ADDENDUM NO.2

PCHA-IFB-2022-004 GENERAL CONTRACTOR SERVICES – MAGNOLIA OAKS NEW CONSTRUCTION

Date: September 8, 2022

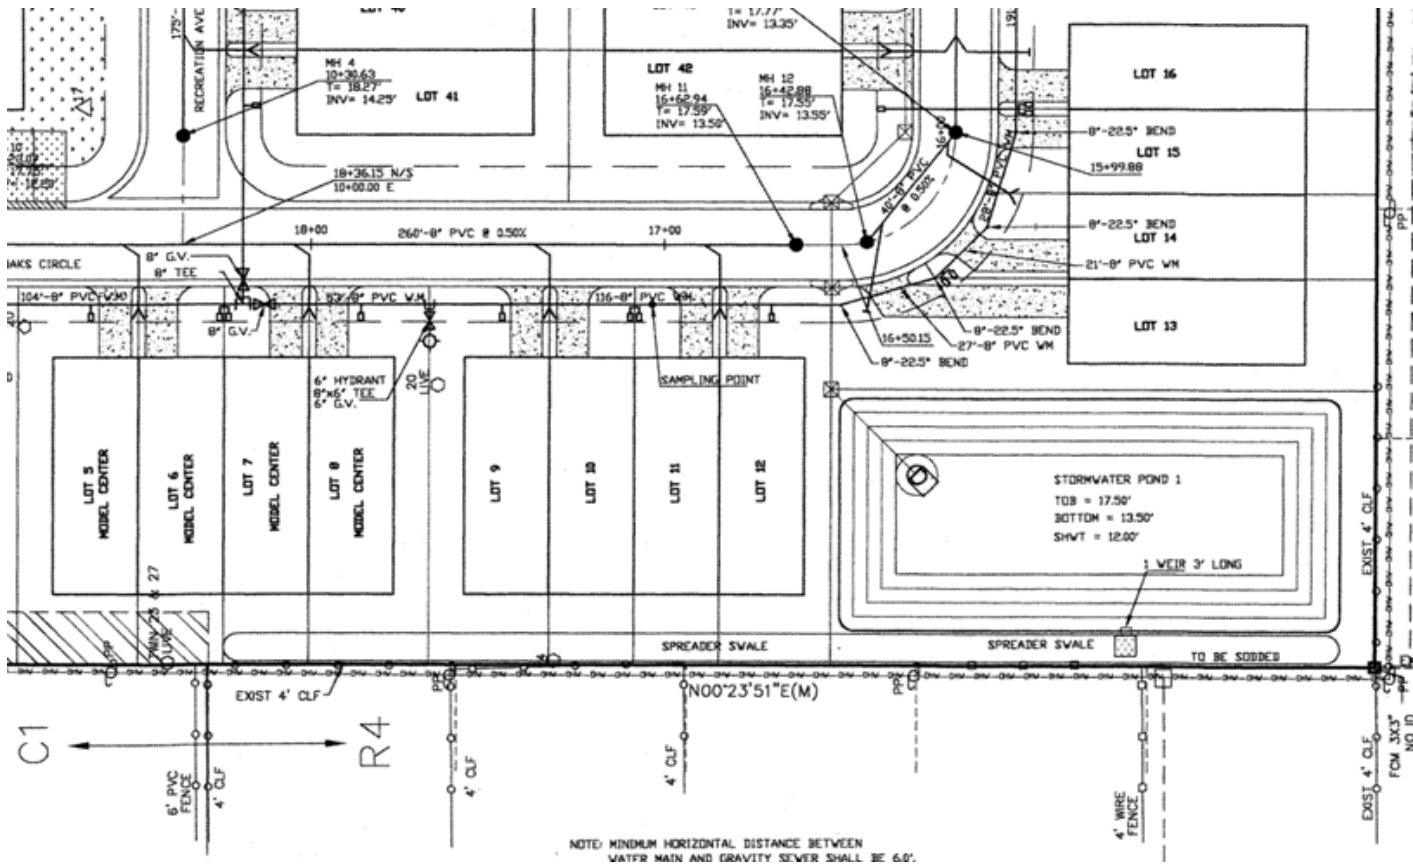
26. The civil plans do not have fire lines run to the buildings. Please advise.

Response: Refer to sheet #17 and #18 Potable Water and Sanitary Sewer Plan for fire line and fire hydrant locations at both east and west side.

The 8" Main Water line feeding the Fire Hydrants and the building pads through both parcels is clearly shown on the civil plans. See page 2 for drawing.
